**G-04503**  
**July 2004**

**SUBJECT: SAFETY RECALL (U.S., EXPORT)**  
**BUNK CONTROL PANEL of certain 9100, 9200, 9300,**  
**9400, and 9900 models built 4/1/1994 thru 6/16/2002**

**Figure 1**

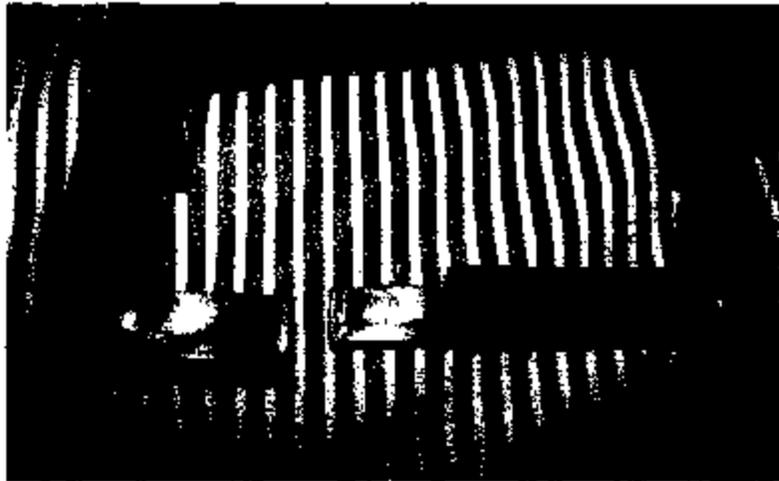
- Water shield flange may interfere with lower switch body

2. Cut a small notch in the flange to clear the bottom of the switch.
